# Town of Franklin

## Planning Board

July 13, 2020

Re: Request for Final Certificate of Completion  
300 Financial Park – Warehouse Development (the Project)  
431 Washington Street, Franklin, MA

SHEET 2 OF 12

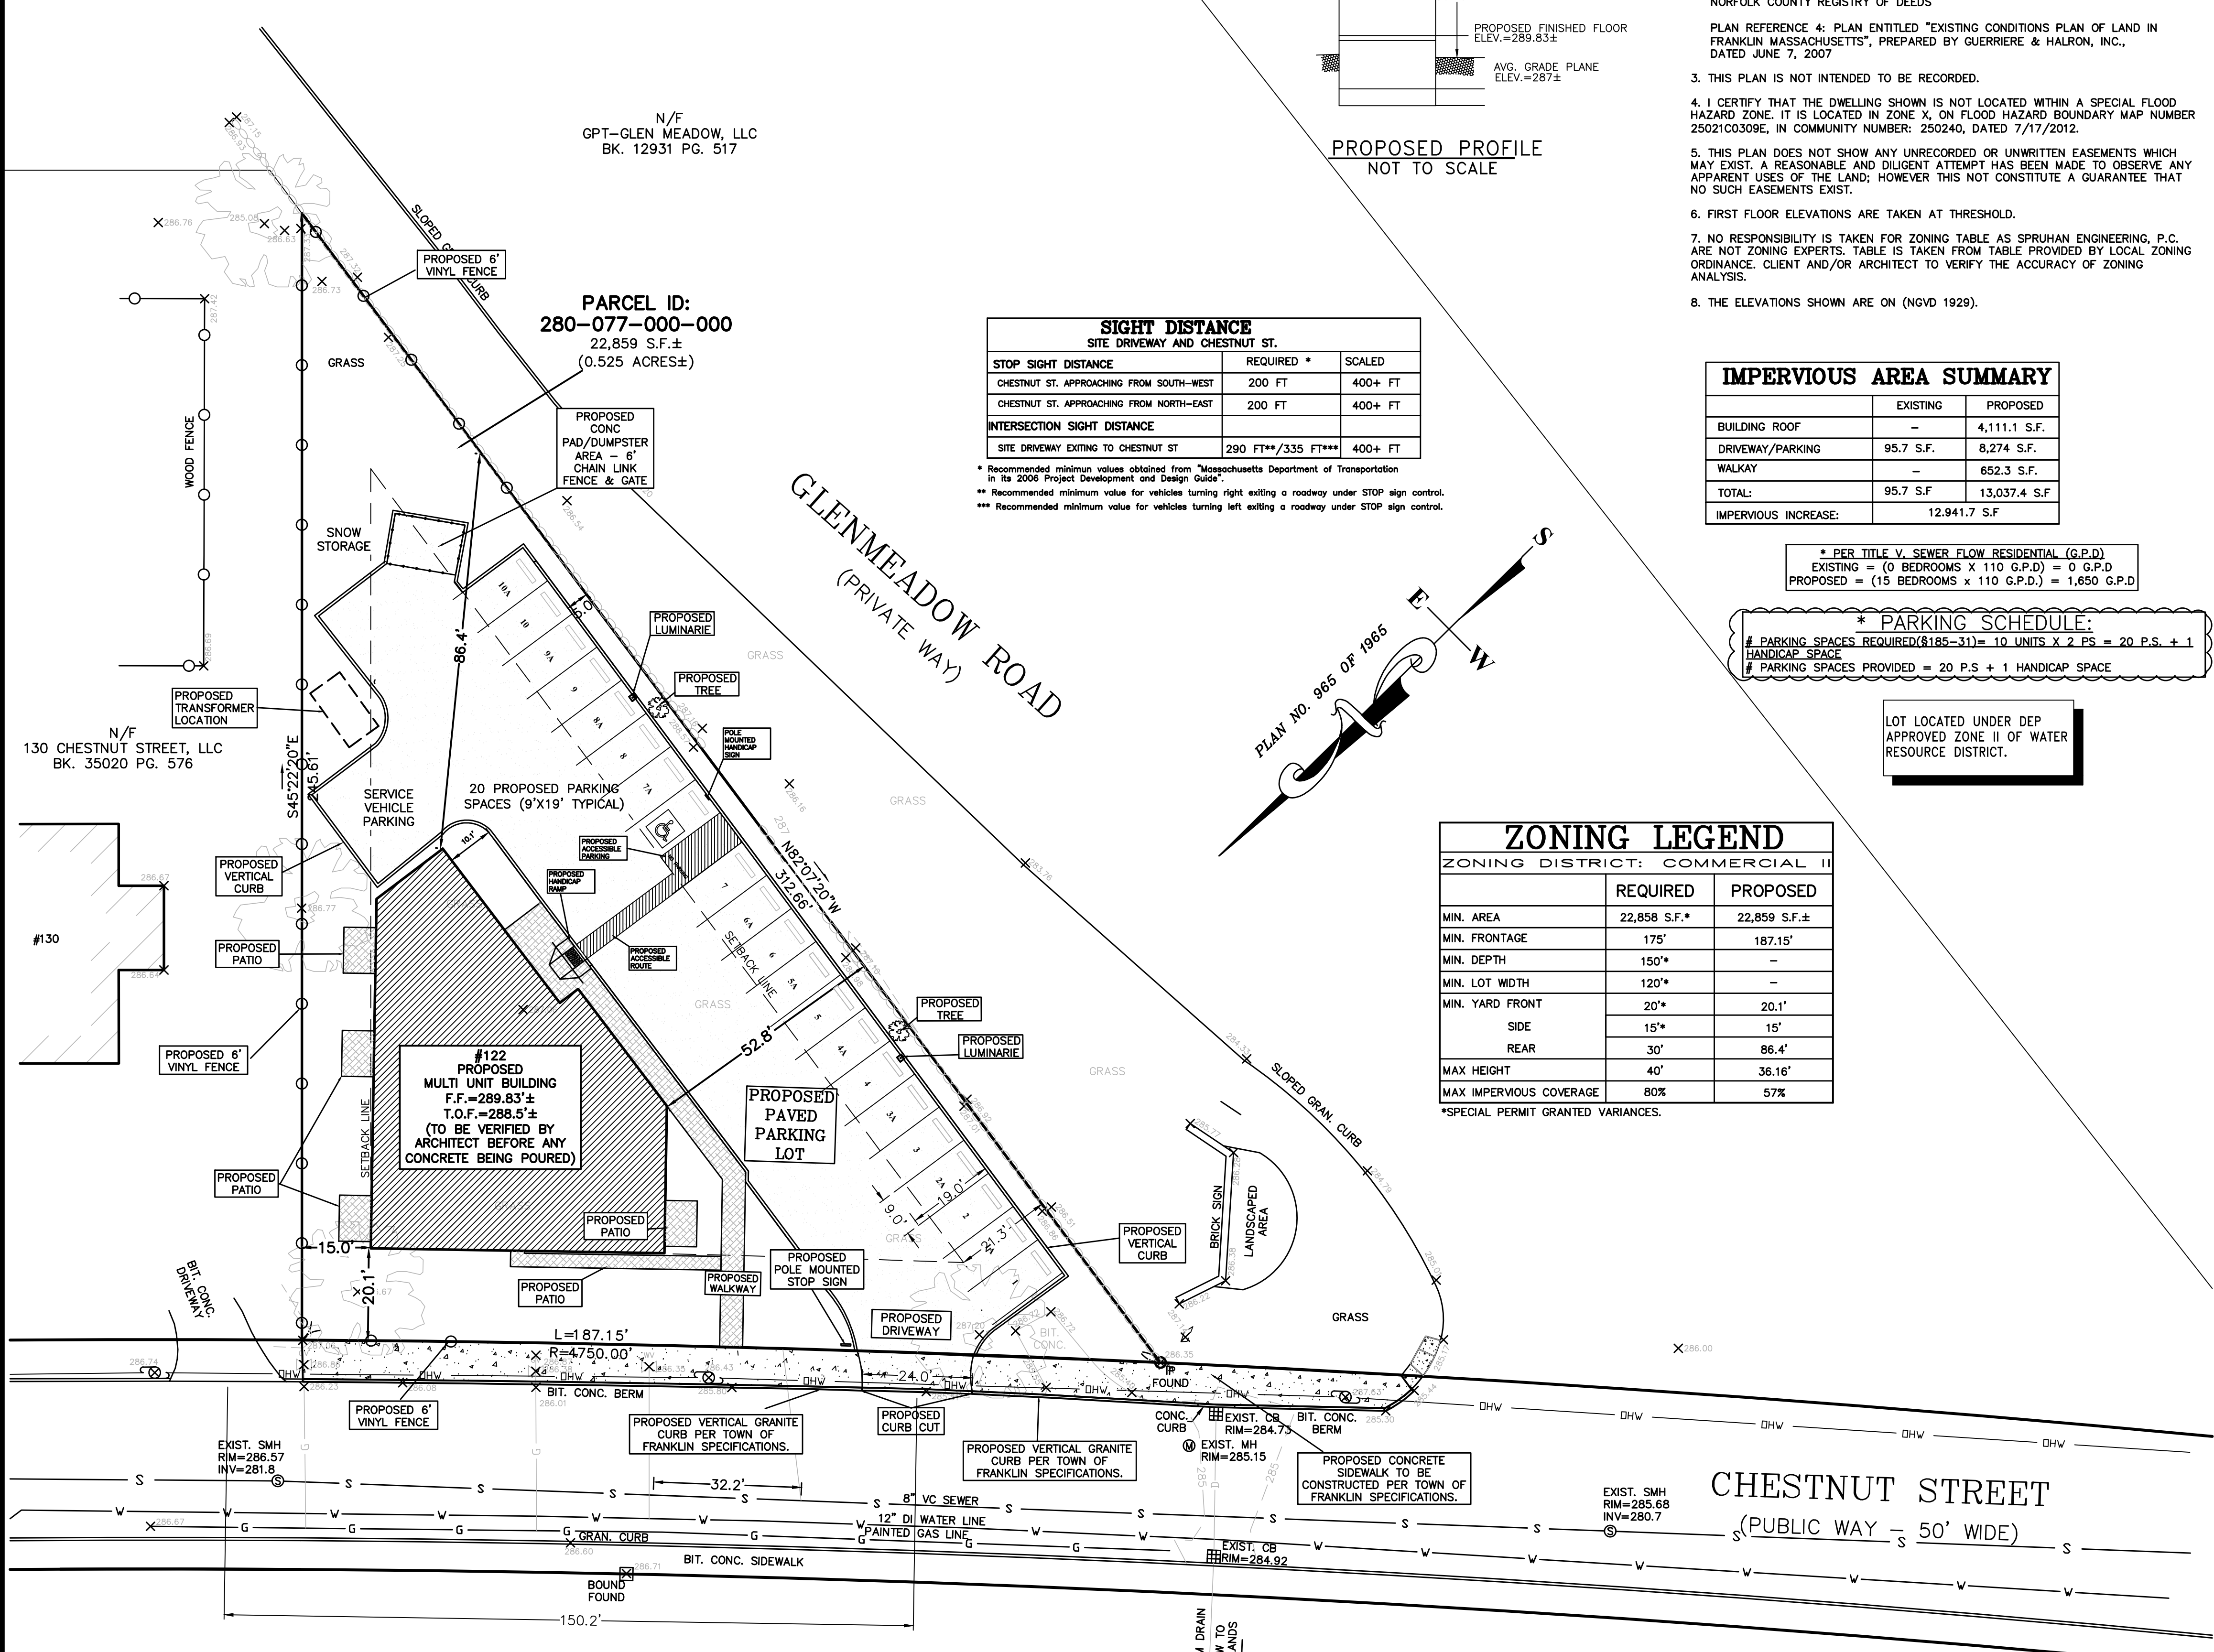
P2. Provide an accessible route from parking space(s) to building in accordance with 521 CMR 10.2, including ramps and crosswalk. SE: Spruhan Engineering provided accessible route from parking spaces to meet the requirements. Please see sheet#2. *BETA2: Accessible route provided. Recommend swapping the location of the accessible space and access aisle to provide a direct route to the ramp.*

P4. Provide trees for parking area in accordance with §185-21.C.(5). SE: Spruhan Engineering updated proposed plot plan showing location of trees for parking to meet the requirements. *Please see sheet#2. BETA2: Trees provided – issue resolved.*

- Z1. Revise Zoning Legend to include proposed dimensions and note/reference variances granted by the Board of Appeals. *SE: Spruhan Engineering updated Zoning Legend. BETA2: Legend revised to include proposed dimensions. BETA defers to the preference of the Board to require references to the granted variances. SE2: Legend has been updated to show granted variances, Please see Sheet #2. BETA3: References to granted variances provided – issue resolved.*

**SE: Legend has been updated to show granted variances, Please see Sheet#2.**

**SE: Handicap striping and pole mounted handicap accessible sign has been added to the plan, Please see Sheet#2**

**SE: Location of the accessible route has been updated. Please see Sheet #2.**

**SE: Driveway entrance has been relocated and dimension added to the plan. Please see Sheet #2.**

**SE: Sight distance chart has been added to plan, Please see Sheet#2.**

**SE: Parking Schedule has been added to the plan. Please see Sheet#2.**
